802.1CB

Failure Mode Considerations

Johannes Specht	johannes.specht AT uni-due.de	Univ. of Duisburg-Essen
Soheil Samii	soheil.samii AT gm.com	General Motors
Helge Zinner	helge.zinner AT de.bosch.com	Robert Bosch GmbH

Issue 1: Cut-Through and Corrupt Data

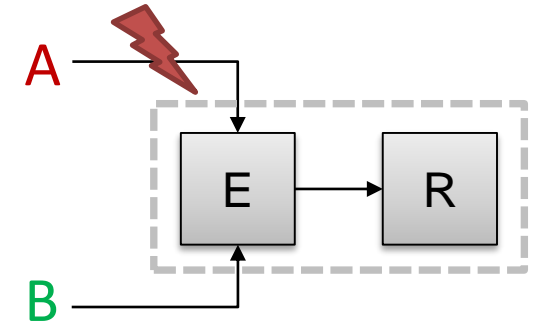
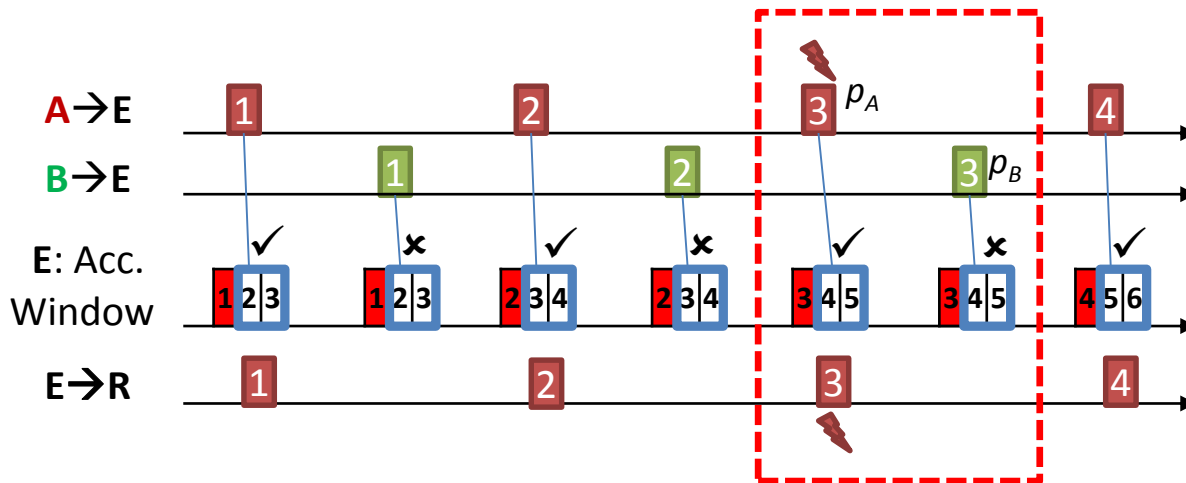
- *Message corruption* on path A causes data error in a packet p_A . At least E is performing cut-through forwarding.
- Consequence:
 - p_A is accepted by E, elimination of (fault free) duplicate p_B from channel B
- Present countermeasures:
 - **None:** FCS check in E is performed at the end of transmission

Issue 2: Cut-Through and Corrupt Sequence Numbers

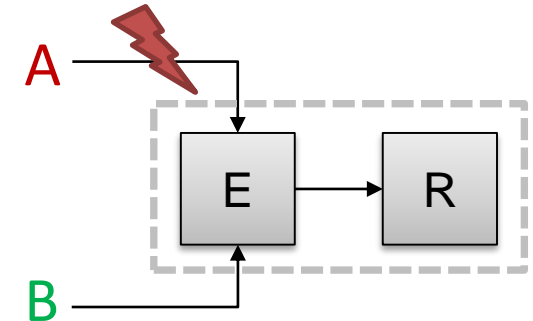
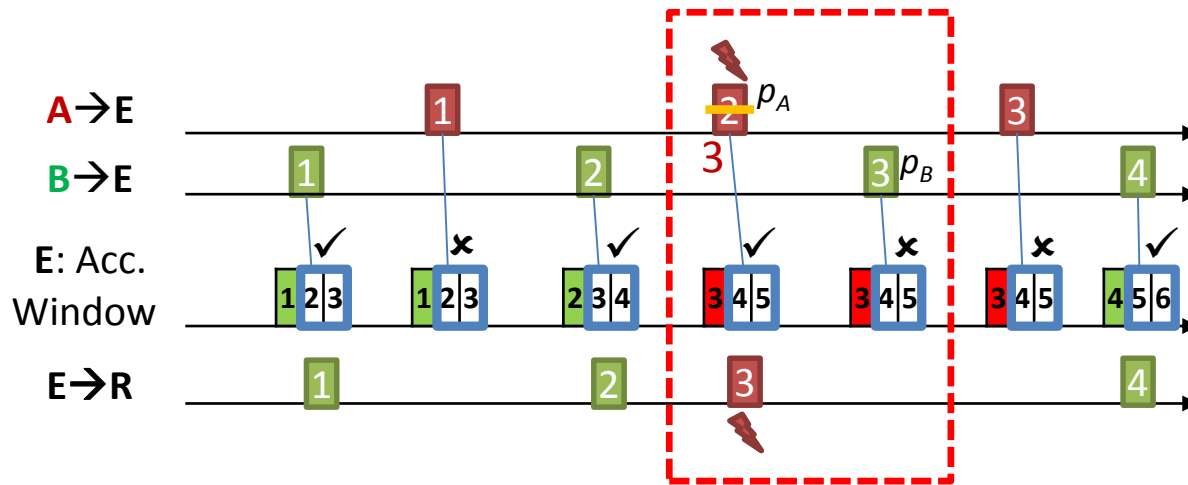
- *Message corruption* on path A causes erroneous sequence number in a packet p_A . At least E is performing cut-through forwarding.
- Consequence:
 - p_A is accepted by E, elimination of (fault free) duplicate p_B from channel B
 - In case of multiple broken sequence numbers, path A can (falsely) take over sequence number alignment in E
- Present countermeasures:
 - **None:** FCS check in E is performed at the end of transmission

Issue 4: (Any) Message repetition by bridges

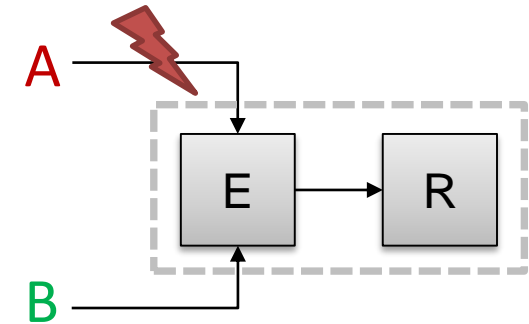
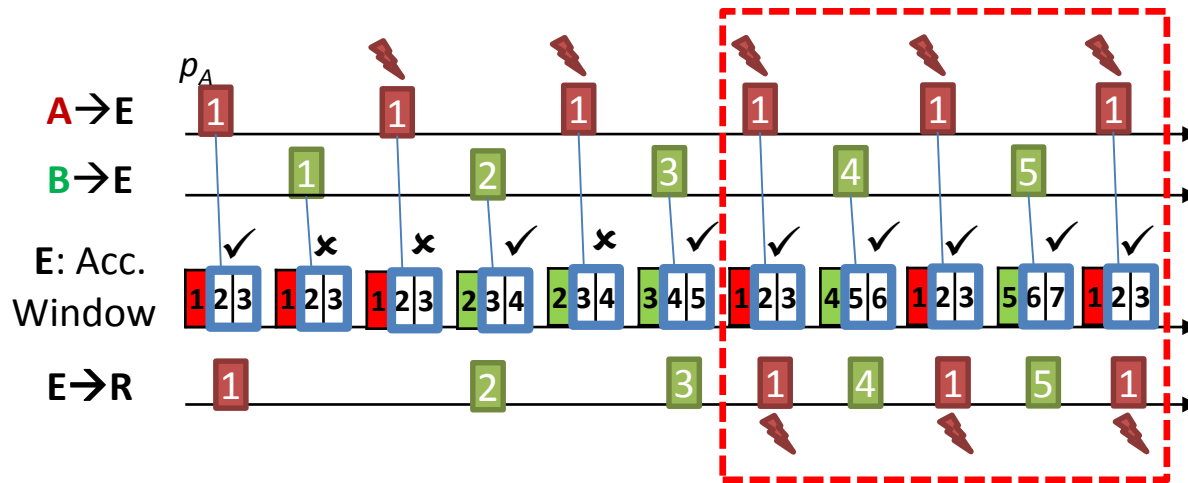
- *Message repetition* on path A causes repeated transmission of a packet p_A .
- Consequence:
 - Alternating alignment of the sequence history window to the sequence number of path A and path B (reset at “nearly” every sequence number), i.e.

$$\dots \rightarrow p_A \rightarrow p_{B,1} \rightarrow p_A \rightarrow p_{B,2} \rightarrow p_A \rightarrow p_{B,3} \rightarrow \dots$$
 - „Nearly“ duplicate load sent by E, may cause false positive 802.1Qci diagnosis of E by R. **R may block E entirely.**
- Present countermeasures:
 - **None**
